Subject: MHI's Response to US-APWR DCD RAI No. 1094-7466 (SRP 07.01)

Response to US-APWR DCD RAI No. 1094-7466 (SRP 07.01)

RAI NO.:	1094-7466
SRP SECTION:	07.01 – Instrumentation and Controls – Introduction
APPLICATION SECTION:	07.01 – Instrumentation and Controls – Introduction
DATE OF RAI ISSUE:	3/27/2014

QUESTION NO.: 07.01-46

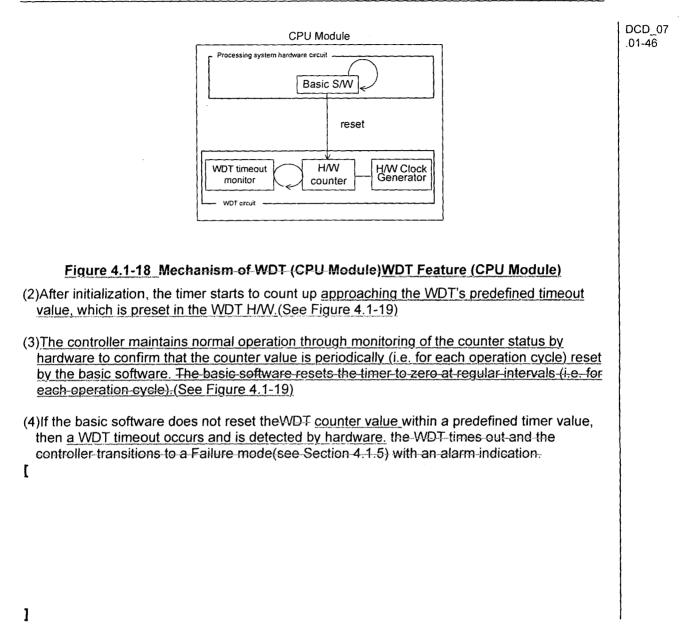
Section 4.1.5.5.2 Output Module	[
Figure 4.1-18, Mechanism of WDT (CPU Module) Figure depicts a graphical representation of the WDT mechanism; however, it does not represent detailed interactions of the WDT circuitry to the circuitry involving the platform software.	Detailed graphical depiction is needed to determine any dependencies arising from the interactions of the WDT circuitry and the platform software.
Figure 4.1-19, WDT's Mounted in MELTAC Platform []	1

Section 4.1.5.5.2 Output Module [NRC Staff Request
	<u>MHI Answer</u> [
Figure 4.1-18, Mechanism of WDT (CPU Module) Figure depicts a graphical representation of the WDT mechanism; however, it does not represent detailed interactions of the WDT circuitry to the	J NRC Staff Request Detailed graphical depiction is needed to determine any dependencies arising from the interactions of the WDT circuitry and the platform software. MHI Answer MHI will add detailed graphical descriptions in Figure 4.1-18 and revise the description of Subsection 4.1.5.7 to explain the interactions of the WDT circuitry and the platform software.
circuitry involving the platform software. Figure 4.1-19, WDT's Mounted in MELTAC Platform [NRC Staff Request
3] <u>MHI Answer</u> [
]

(a) Function of the WDT Figure 4.1-18 shows the arrangement of the WDT in the CPU Module, and Figure 4.1-19 shows how the WDT operates regarding count-up, counter reset, and timeout when the counter value reaches a predefined value. The sequence of WDT operation in the event of a failed module is discussed below. A failure in the CPU Module has been used as an example; the operation of the WDT in other modules is identical.						
	DCD_07 .01-46					
CPU Module Basic S/W Reset Counter H/W Clock Generator Reset Reset S/W stop
